DEVELOPMENT FACILITATION TEAM (DFT) APPLICATIONS

OFFICIAL NOTIFICATION OF DECISION

John R. Metz 366 Los Ranchos NW Albuquerque, NM 87107 **Project # PR-2022-007999** SI-2023-01621- Site Plan- EPC

CONDITIONS OF APPROVAL - SI-2023-01621

Airport Protection Overlay Considerations (APO)

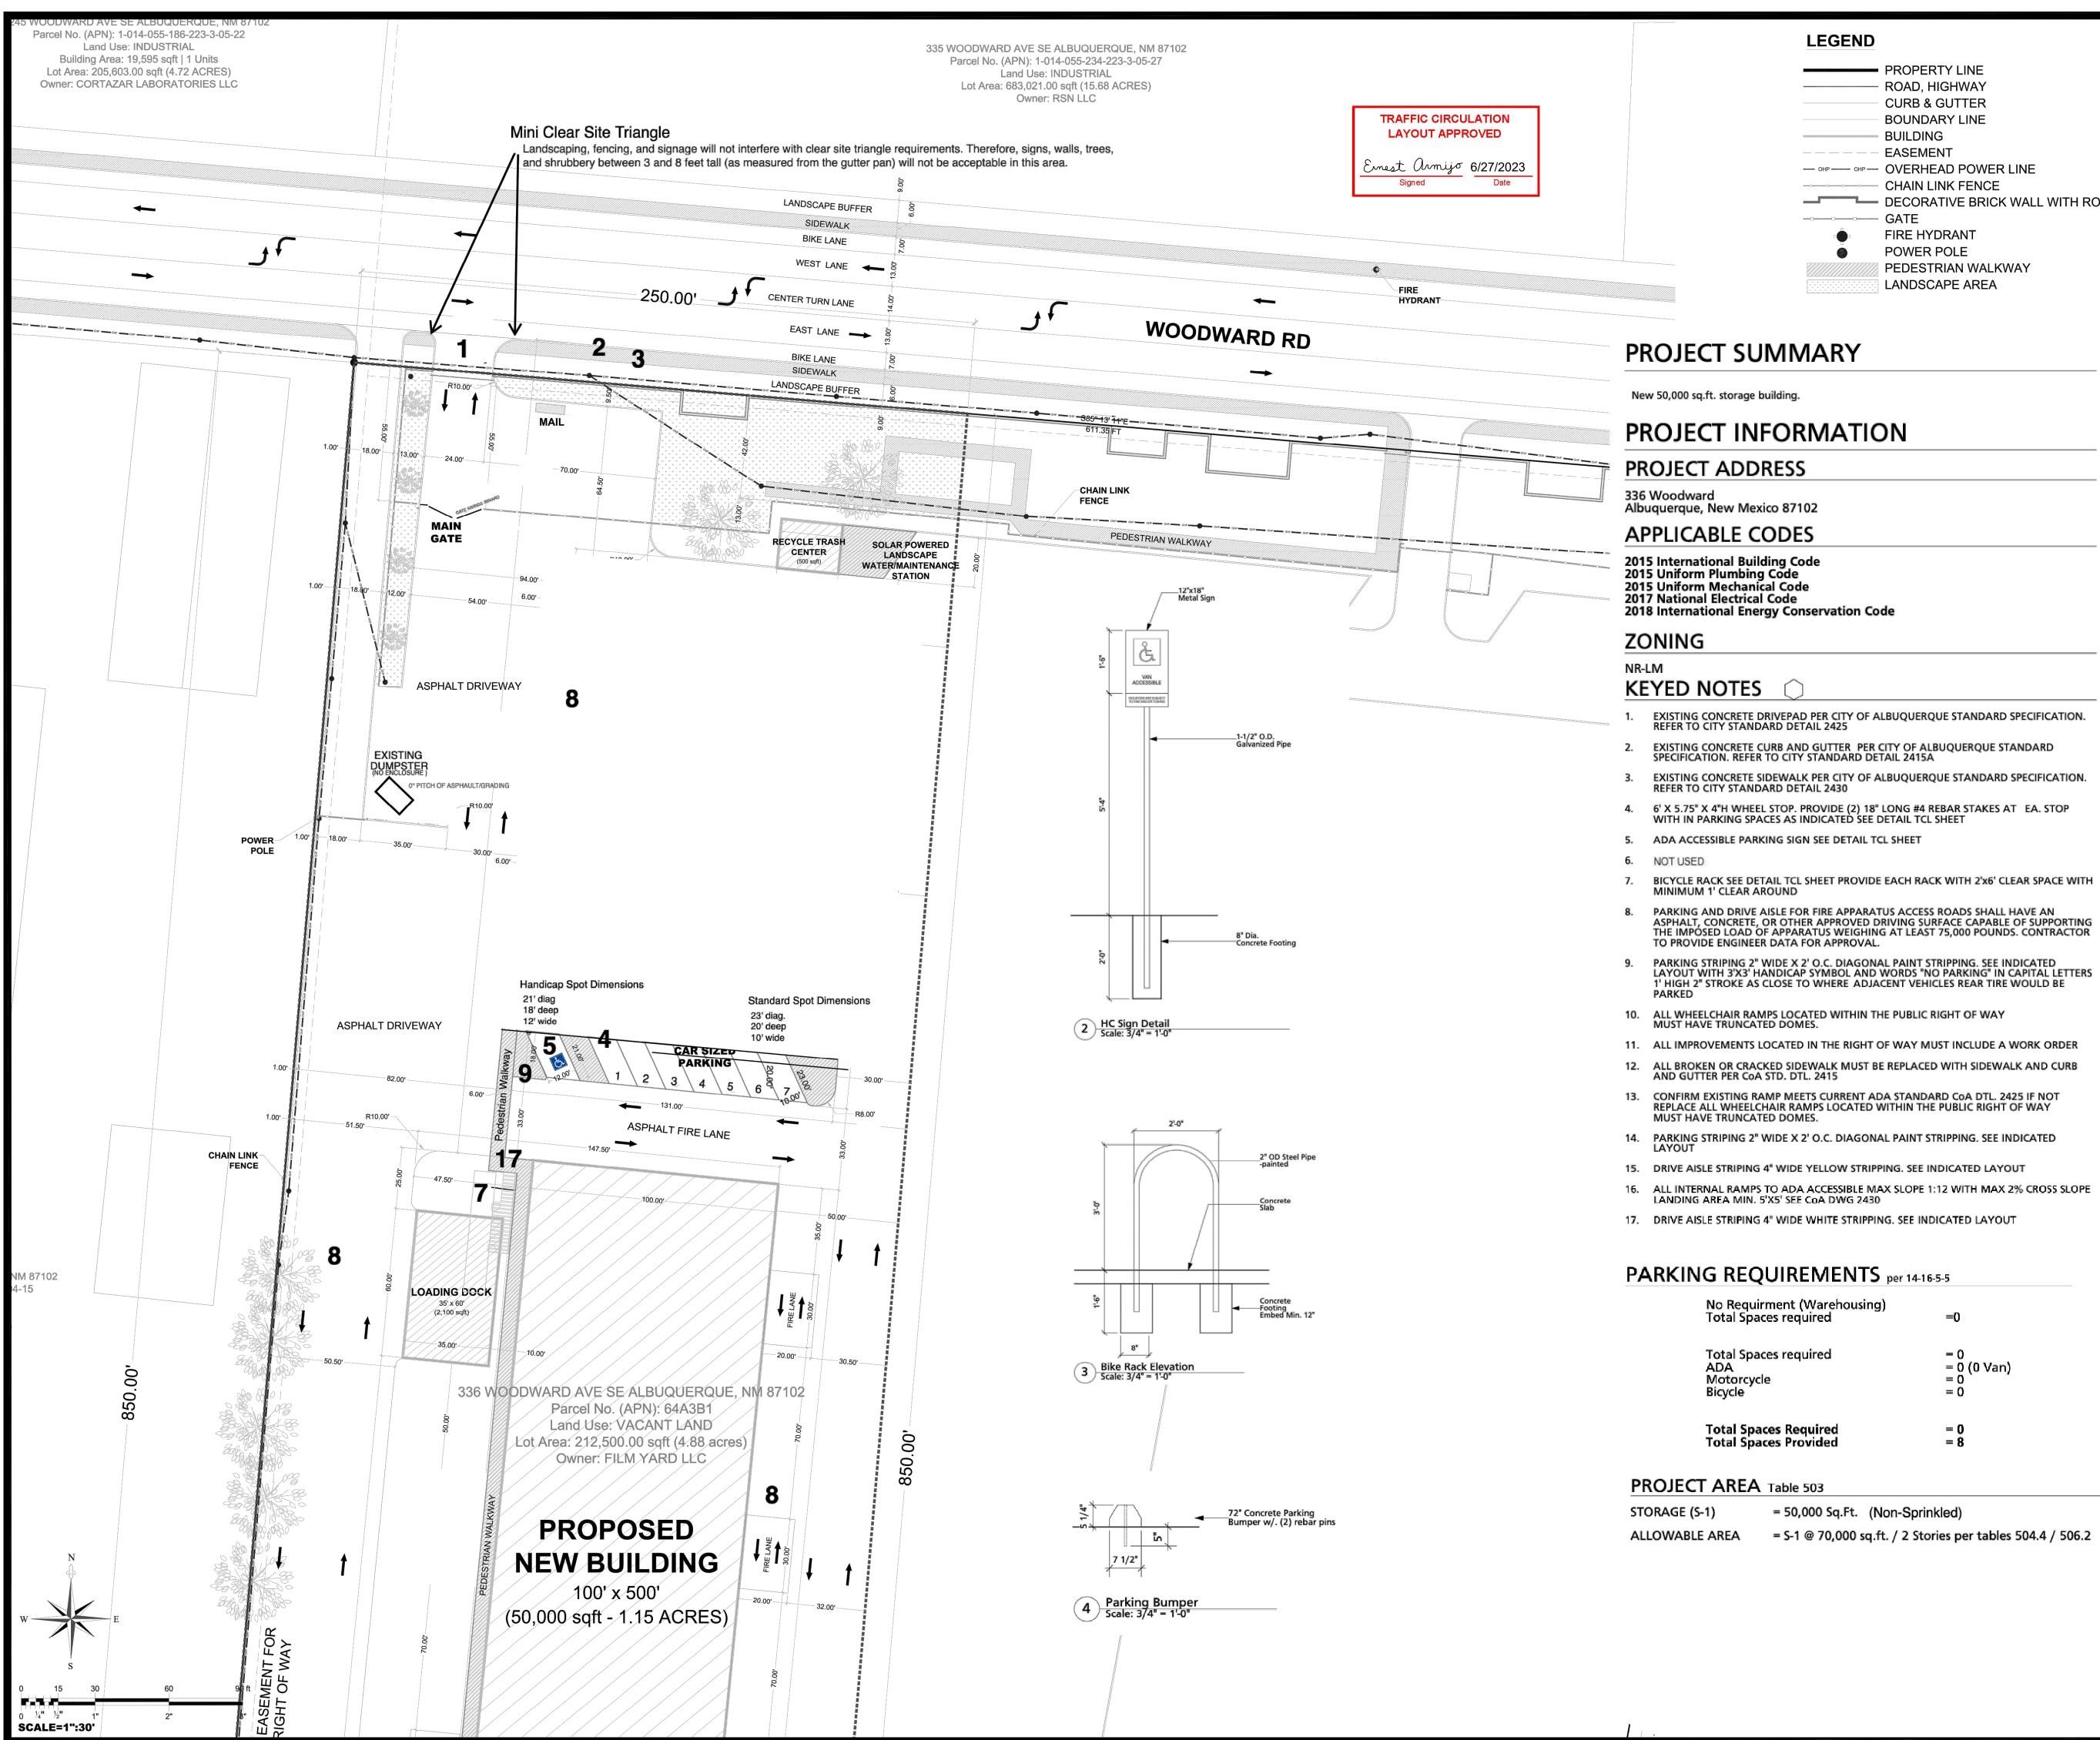
- 3. The Site Plan shall be in compliance with all APO 3-3 standards.
- 4. Airport Protection Overlay Zone (APO 3-3)
 - A. The Airspace Protection Sub-Area analysis shall be its own detail sheet.

- B. Light Reflective Value (LRV) shall be called out for each surface pursuant to IDO 3-3(D)(2) Reflectivity.
 - C. A note shall be added to the Site Plan stating that Structure and any other features therein comply with the glare and reflectivity standards per IDO 3-3(D)(2) Reflectivity.

#3... the site plan is in compliance with all APO standards, a separate summary document was supplied and the updated plan has comments to this effect

#4... is addressed with notes on the site plan... the site has no signage or reflective surfaces to further evidence.

It is required that the Subject Site and proposed structure be lower than 5505 feet above sea level. According to the US Geological Survey chart (below) the site is below that altitude at 4945 feet. The proposed structure is a single story warehouse which is 46' at its highest point. So the project is within the required height limitations.

It is also required that the project complies with IDO APO 3-3(D)(2) Reflectivity standards. The Proposed meets these standards. The building is a matte gray, with a light gray low reflectability roof the building will have no high reflective surfaces, colors or materials. Site has no signage.

336 WOODWARD AVE SE ALBUQUERQUE, NM 87102 PARCEL #:64A3B1 AREA:212,500.00 sqft (4.88 acres)

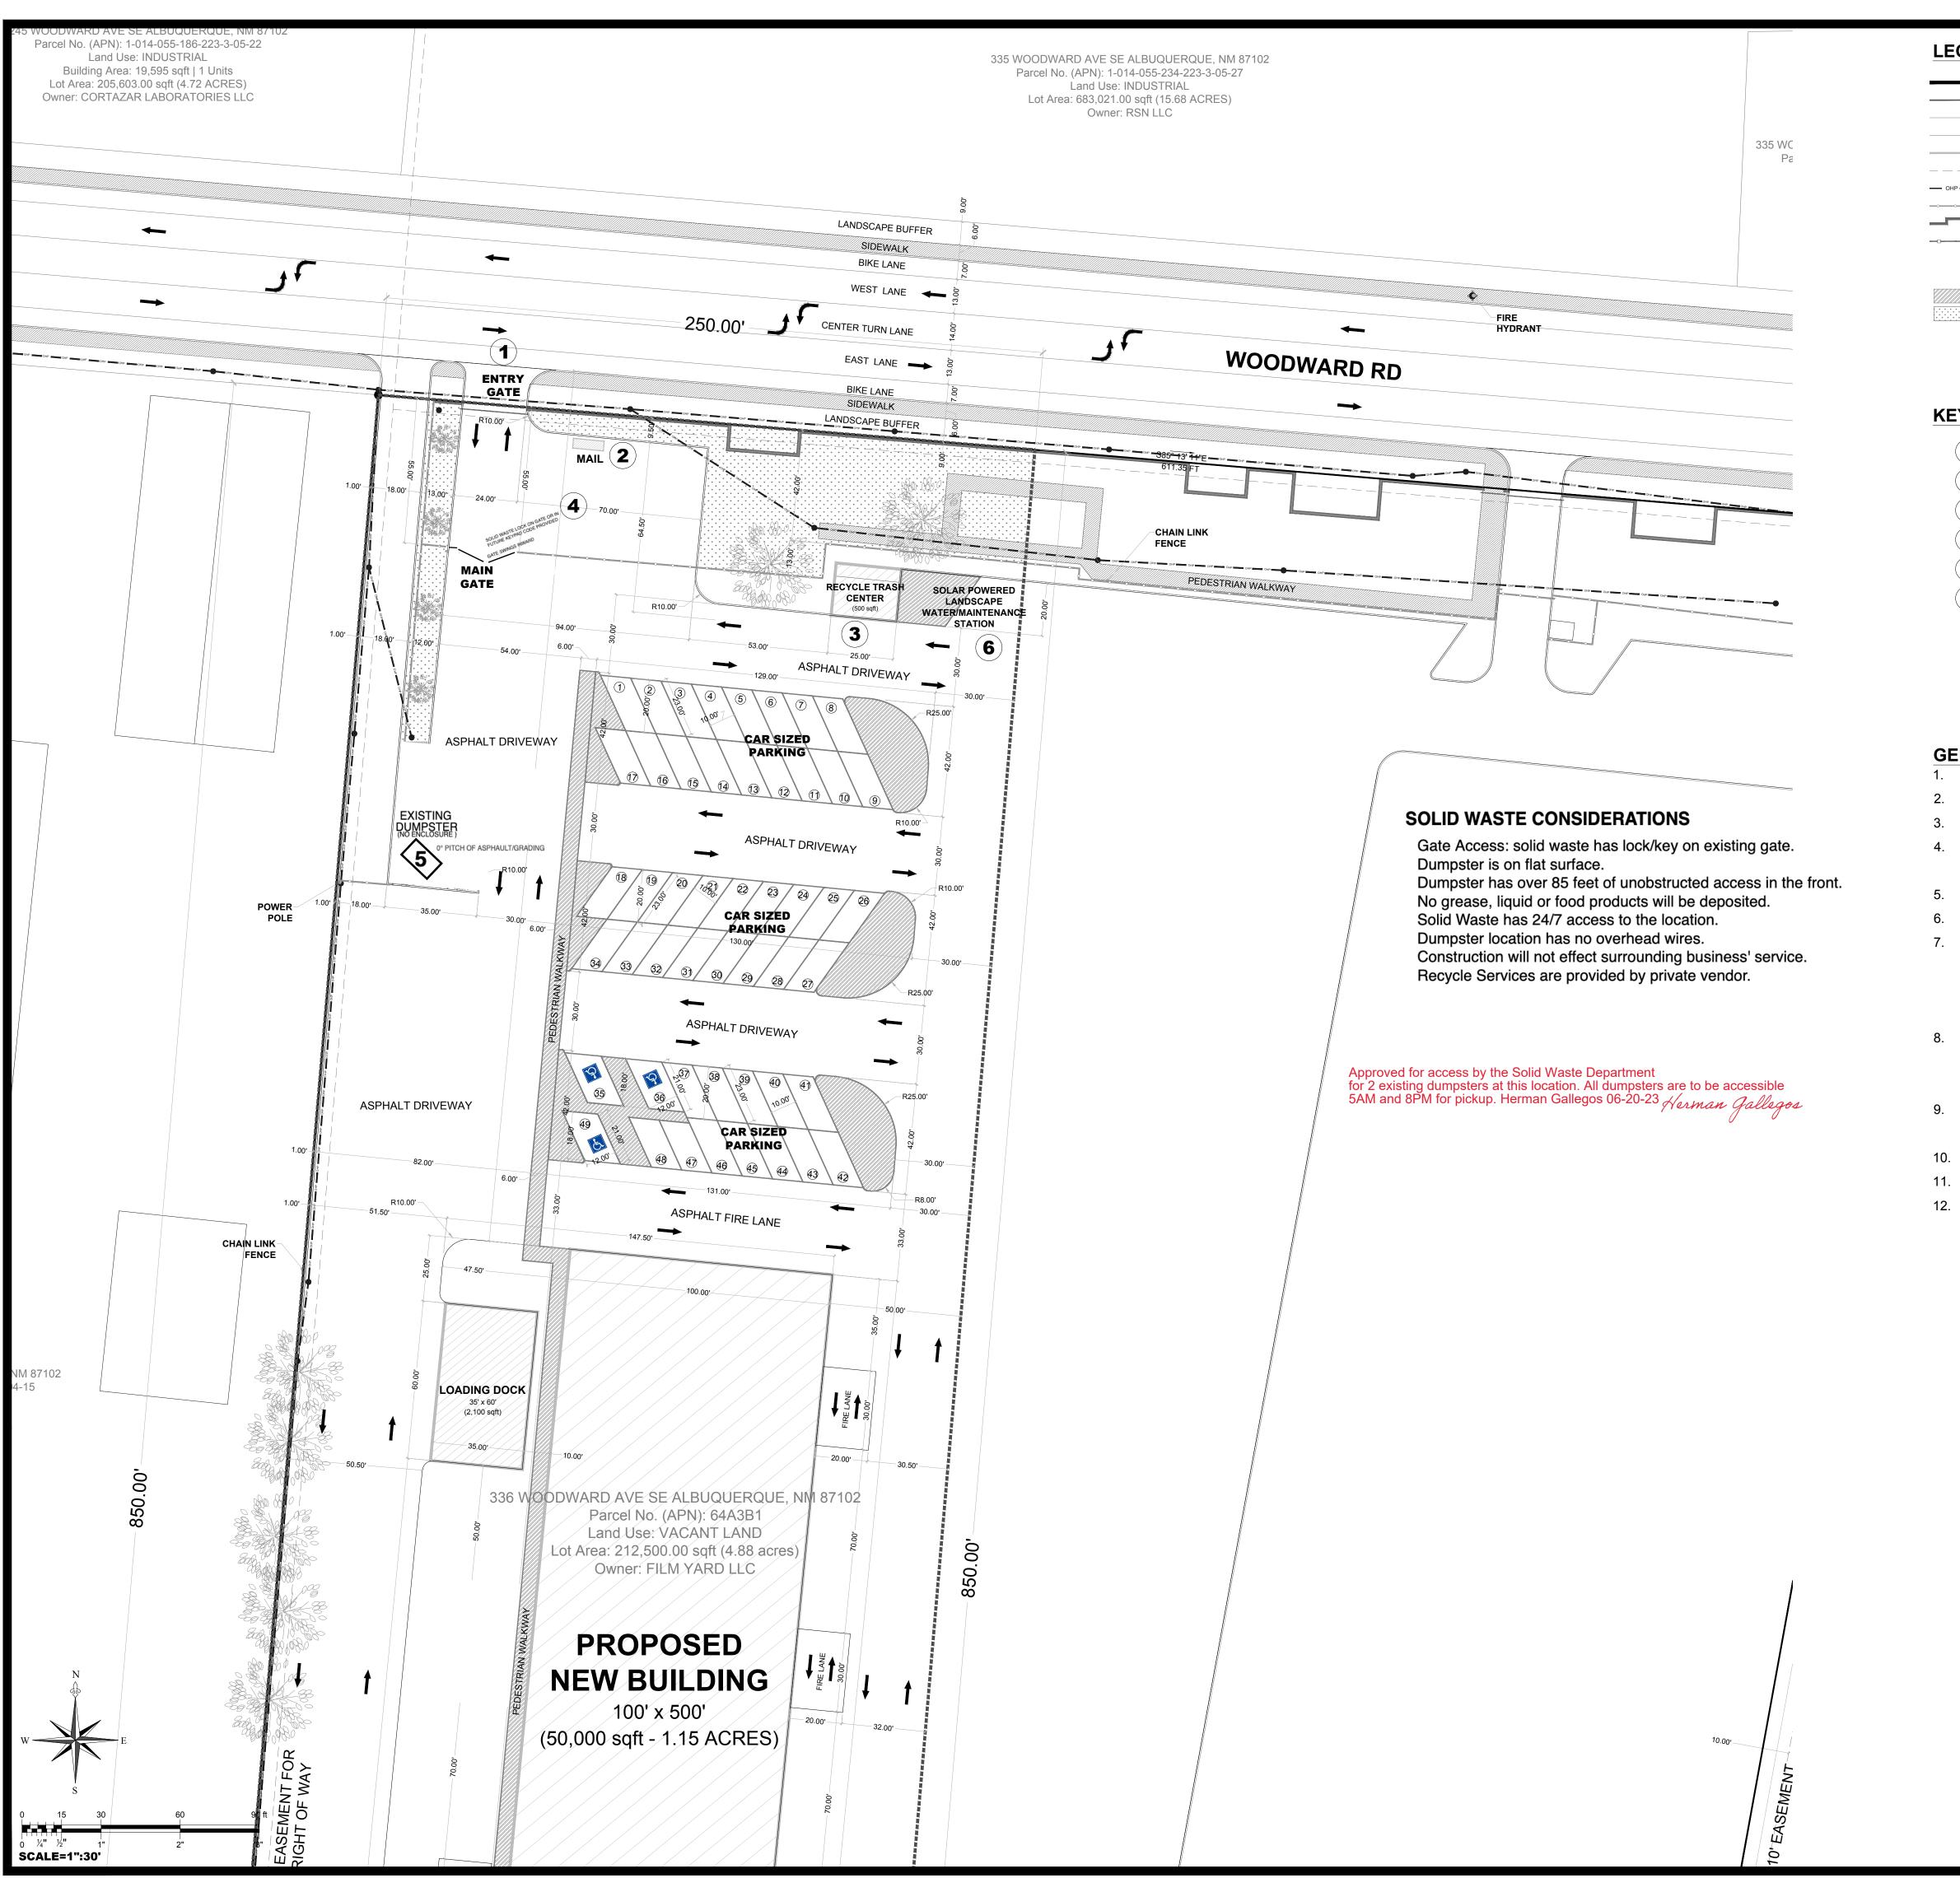
- 6. Site Plan Clean-up
 - A. The Site Plan shall indicate that the entire subject site is 19.1 acres.
 - B. The Site Plan shall indicate areas of the subject site that are expected to be developed in the future.

- C. The Site Plan shall include a Phasing Plan noting that the current proposal is "Phase 1." The Phasing Plan shall note future phases of development.

- D. The Site Plan shall indicate that the proposed warehouse (Phase 1) will be located solely on Parcel 64A3B1, which is 4.74 acres in size.
- 7. CONDITIONS FROM THE MIDDLE RIO GRANDE CONSERVCANY DISTRICT:

- A. The Site Plan shall reference MRGCD Dwg #A-354 and R&C #3128 as well as the widths from the property lines to the centerline of the San Jose Interior Drain.

#6... all comments in this condition are reflected in the updated plan provided.

#7... these comments are reflected on the updated plan... we need a submission contact from you for this.
